##### **1958 Agreement – Consideration of draft corrigenda to existing Regulations proposed by GRPE**

### **Proposal for a Corrigendum 1 to the 06 series of amendments to Regulation No. 83 (Emissions of M<sub>1</sub> and N<sub>1</sub> vehicles)**

The text reproduced below was adopted by the Working Party on Pollution and Energy (GRPE) at its sixtieth session to clarify, correct and update elements of the provisions of Annex 4a to Regulation No. 83. It is based on ECE/TRANS/WP.29/GRPE/2010/8, not amended. It is submitted to the World Forum for Harmonization of Vehicle Regulations (WP.29) and to the Administrative Committee (AC.1) for consideration (ECE/TRANS/WP.29/GRPE/60, para. 19).

**Particulate sampling probe configuration**

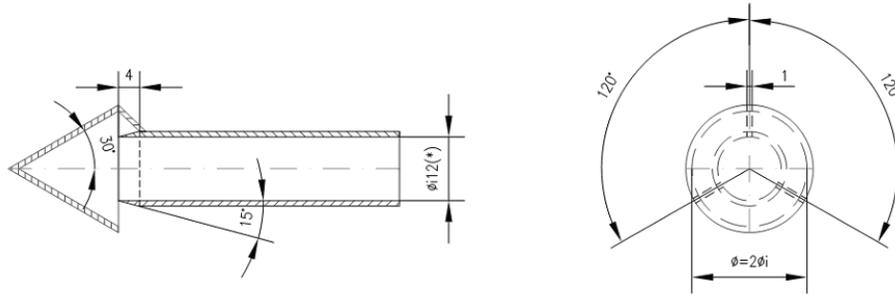
Annex 4a, Appendix 4, Figure 13, amend to read:

(\*) Minimum internal diameter  
Wall thickness ~ 1 mm - Material: stainless steel
